INFORMATION LETTER 206L-05-78

TO: All Owners/Operators of Bell 206L series Helicopters

SUBJECT: FILTER 50-075-1, INSPECTION AND RECALL OF

Figure 1. Filter 50-075-1 Physical Difference

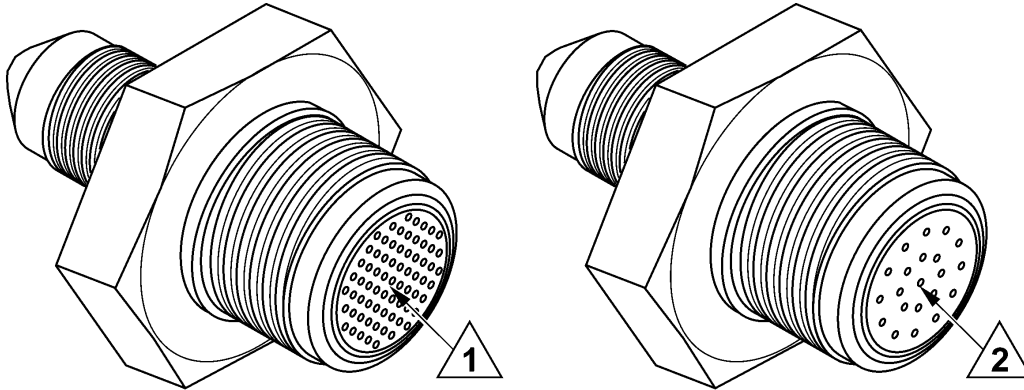
This information letter is issued to report that in some filter units 50-075-1, the screen portion of the filter was not manufactured with the correct number of holes. Testing has confirmed this condition is not detrimental to the normal operation of the transmission and freewheel oil system. However, Bell Helicopter recommends that filter units with an incorrect hole pattern be identified and replaced.

To identify the configuration to be removed from service, examine the screen hole pattern (refer to Figure 1). Replace any unacceptable filter unit at your earliest convenience.

- 1** Acceptable hole pattern. A minimum of 65 holes are required.
- 2** Unacceptable hole pattern to be removed from service.

Bell Helicopter will supply parts necessary to perform this task, consisting of packing M83248/1-906 and filter 50-075-1, at no charge. This credit is available for non-compliant filters that are installed or in stock.
